# SAN FRANCISCO-OAKLAND BAY BRIDGE

## SUMMARY OF WELDING STUDIES

April 2005 – July 2005

Fig. 1: Partial Weld Detail

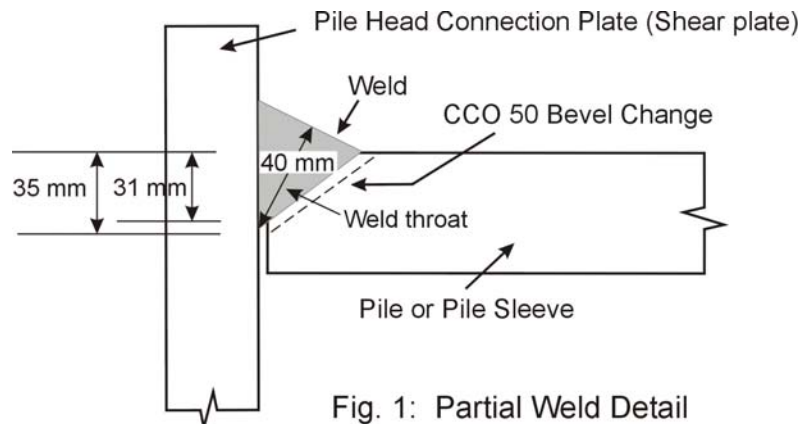
The geometry and physical properties of the welds were also assessed. Contract Change Order number 50 increased the overall weld size by enlarging the bevel in the pile and pile sleeve (see Fig. 1). This was done to streamline the inspection process by eliminating Ultrasonic Testing (UT), originally required by the contract as the method for verifying the depth of preparation. The net result of this change is a larger weld than what was originally designed.
